BZA2005-00018

SITE PLAN

Wichita-Sedgwick County Metropolitan Area Planning Department

Re: BZA2005-00018: A Zoning Adjustment to permit an accessory structure to be placed in front of the principal structure on less than five acres of land.

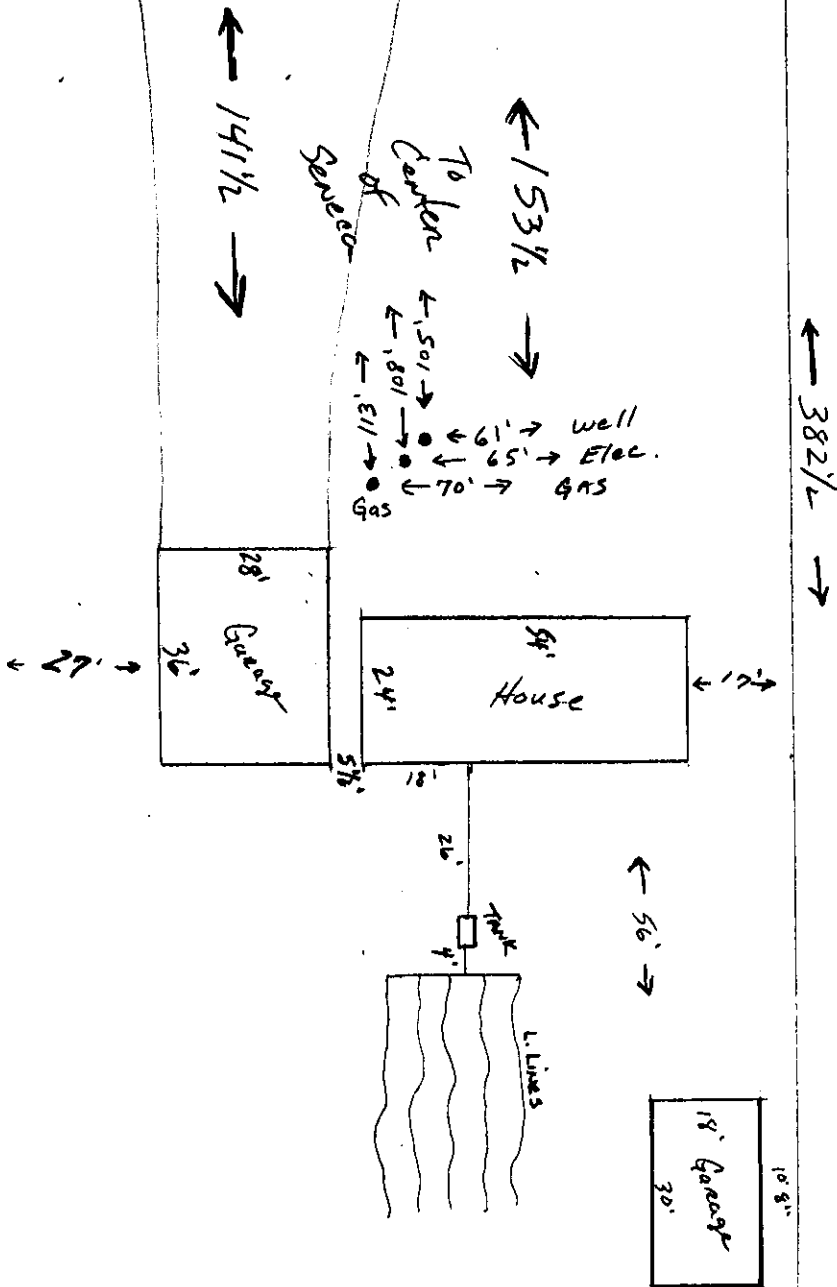
- 1) The site shall be developed in general conformance with the approved site plan, and all permits necessary to construct the improvements shall be acquired.
- 2) The allowance of an accessory structure in front of the principal structure shall apply only to the "Garage" illustrated on the approved site plan. All other structures or additions on the subject property shall conform to the development standards of the Unified Zoning Code unless a separate Zoning Adjustment or Variance is granted.
- 3) If the Zoning Administrator finds that there is a violation of any of the conditions of the Zoning Adjustment, the Zoning Administrator, in addition to enforcing the other remedies set forth in the Unified Zoning Code, may, with the concurrence of the Planning Director, declare that the Zoning Adjustment is null and void.
